**CALIFORNIA COASTAL COMMISSION**

**APPEAL STAFF REPORT  
DE NOVO REVIEW**

**APPEAL NO.:** A-2-DYC-00-027

**PROJECT DESCRIPTION:** Construction of a 22,580-square-foot church and 131-space parking lot, and lot line adjustment between KCPC and City parcels

**SITE PLAN**

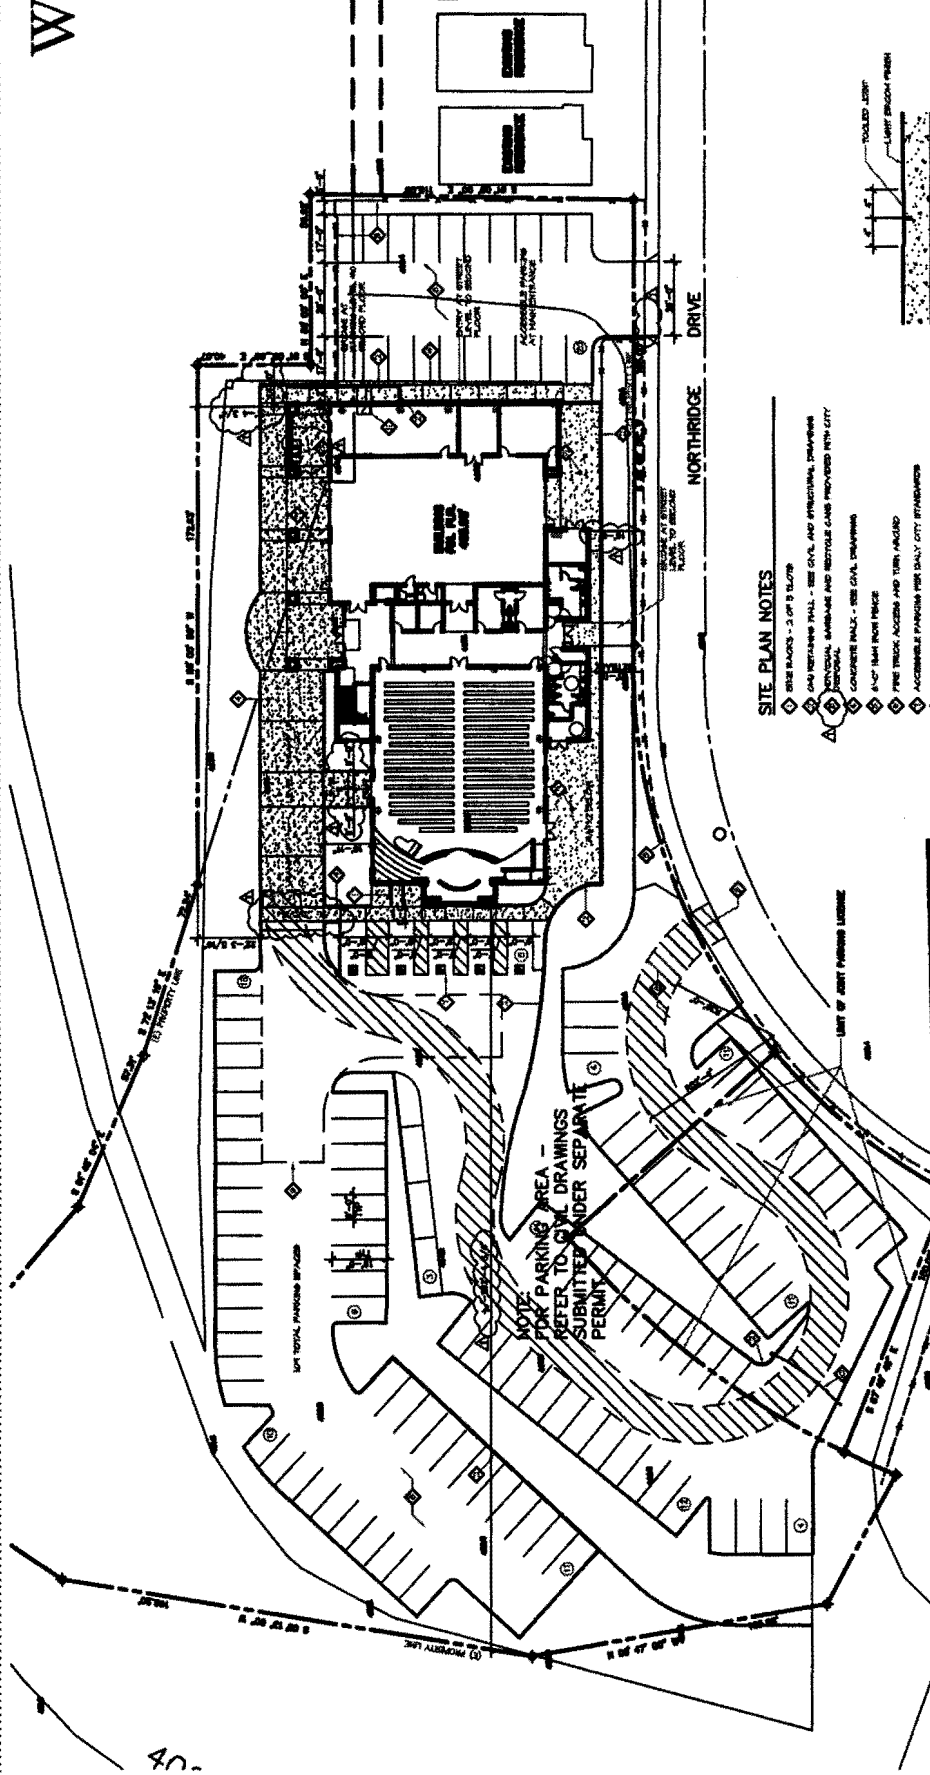
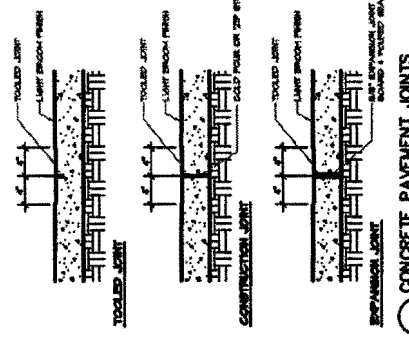
- B. The stormwater pollution prevention plan shall incorporate the BMPs described below:
1. Parking Lots and Buildings
    - a. **PRIOR TO ISSUANCE OF PERMIT,** the applicants shall modify site plans to remove the 53 parking spaces in the western parking lot closest to bluff. The area where the parking spaces are removed shall be appropriately landscaped to prevent erosion. The applicants shall submit the revised plans for the review and approval of the Executive Director.

In order to comply with LCP Policy 30231 to maintain the quality and biological productivity of coastal waters, **Special Condition 7** requires the applicants to revise the project plans to remove the 53 spaces closest to the coastal bluff in the 111-space western parking lot. The removal of 53 spaces reduces approximately 19,000 square feet of impervious surface. As discussed above in Section 4.2 (Geologic Hazards), the removal of these spaces also ensures that bluff retreat will not encroach into the western parking during the life of the project.

EXHIBIT NO.	13
APPLICATION NO.	A-2-DIC-00-27
KCFC, Daly City	
PROPOSED ONSITE CUT AND FILL

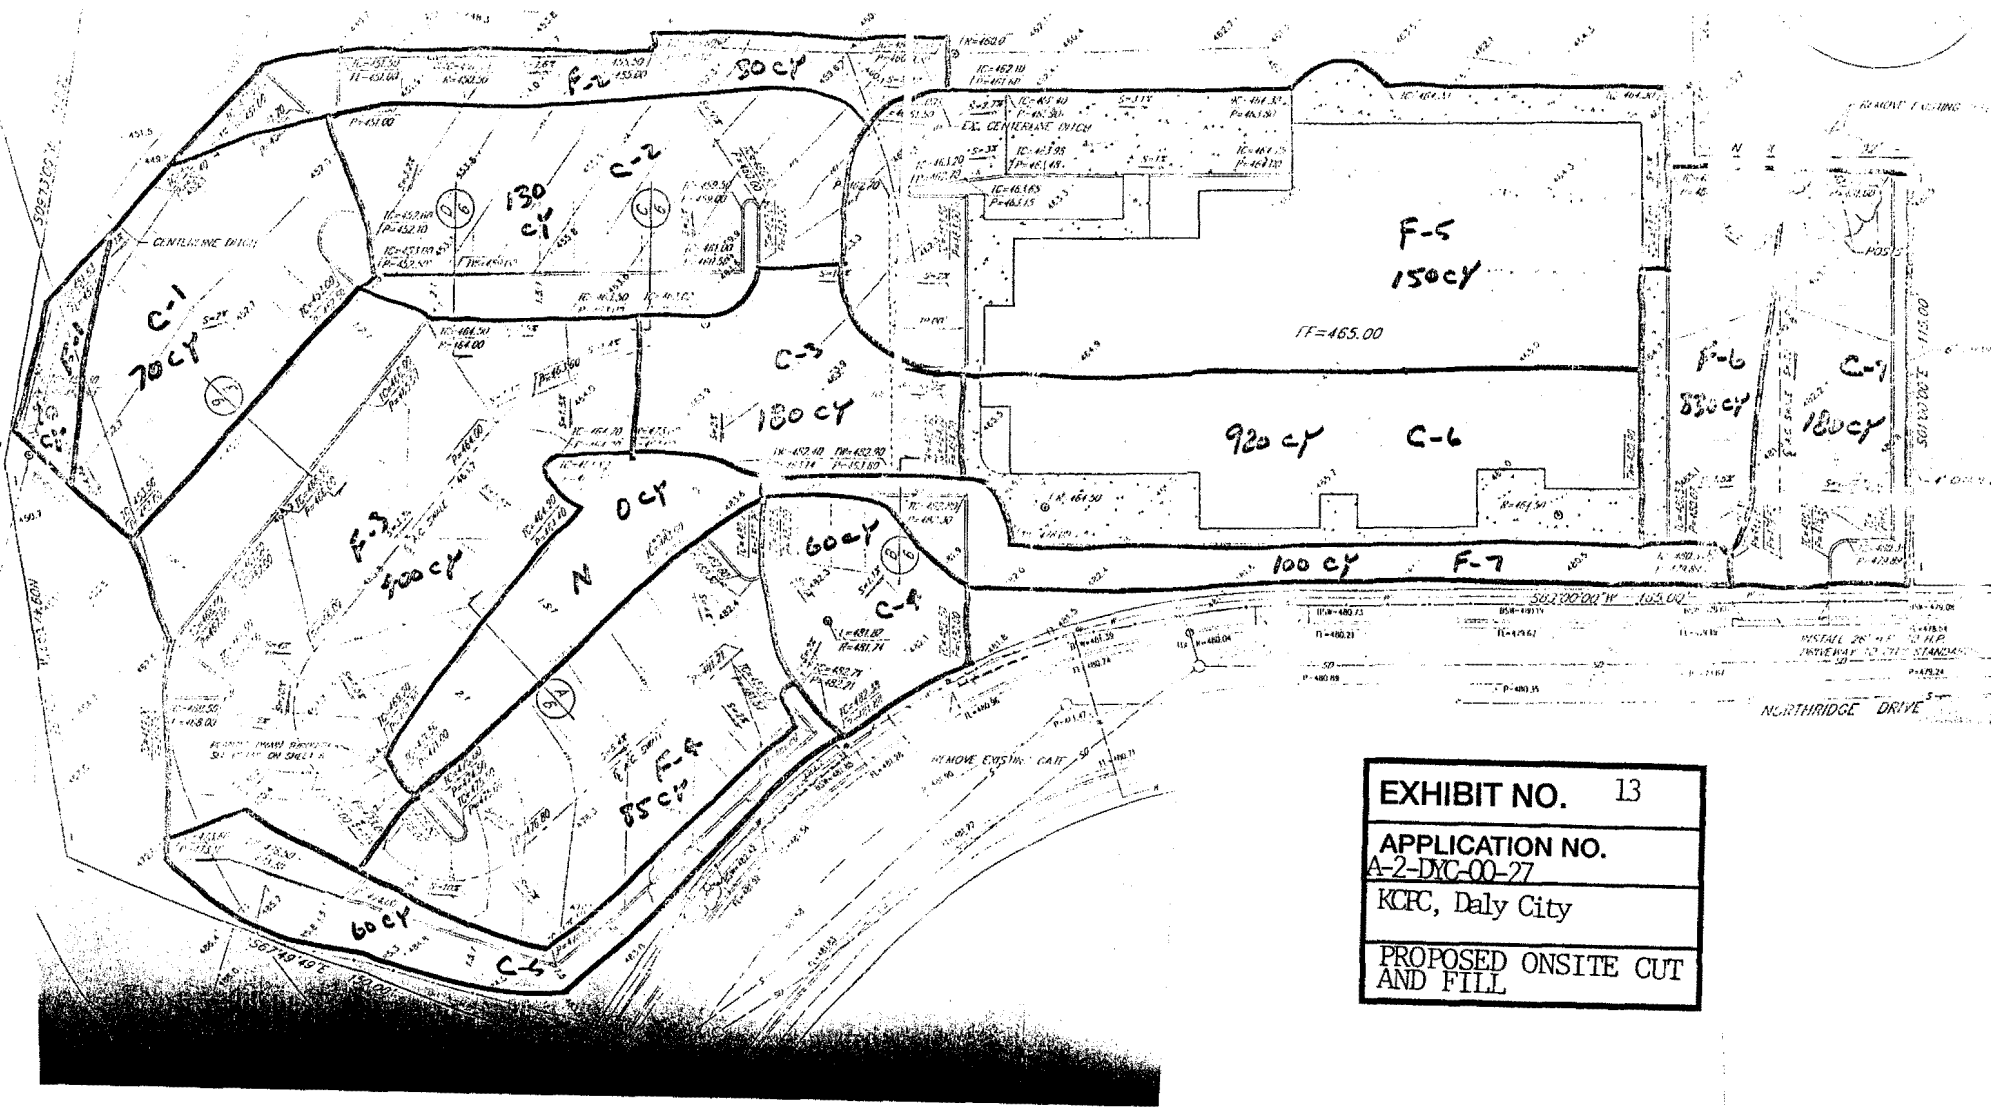
Section 17.27.040 of the Zoning Code requires that the geotechnical report include proposed changes to the project site caused by grading. The applicants have submitted a plan showing the proposed grading on the project site (**Exhibit 13**). The total proposed cut and fill consists of approximately 1,600 cubic yards each and will be balanced on site. The grading is necessary to permit stormwater runoff to properly flow to drainage structures, prevent runoff from collecting at the base of the church, and to prepare the site for construction. Given that the repair of Avalon Canyon removed about 71,000 cubic yards of material from the site and left the project area in its current roughly-graded configuration, the proposed grading of 1,600 cubic yards is relatively minimal. Since the project is conditioned to provide fewer parking spaces in the western parking lot than proposed (see Section 4.4 on Water Quality), the final grading volumes will be even less than 1,600 cubic yards. Therefore, because the proposed grading is for erosion control and drainage purposes, it is consistent with Section 17.27.050(C).
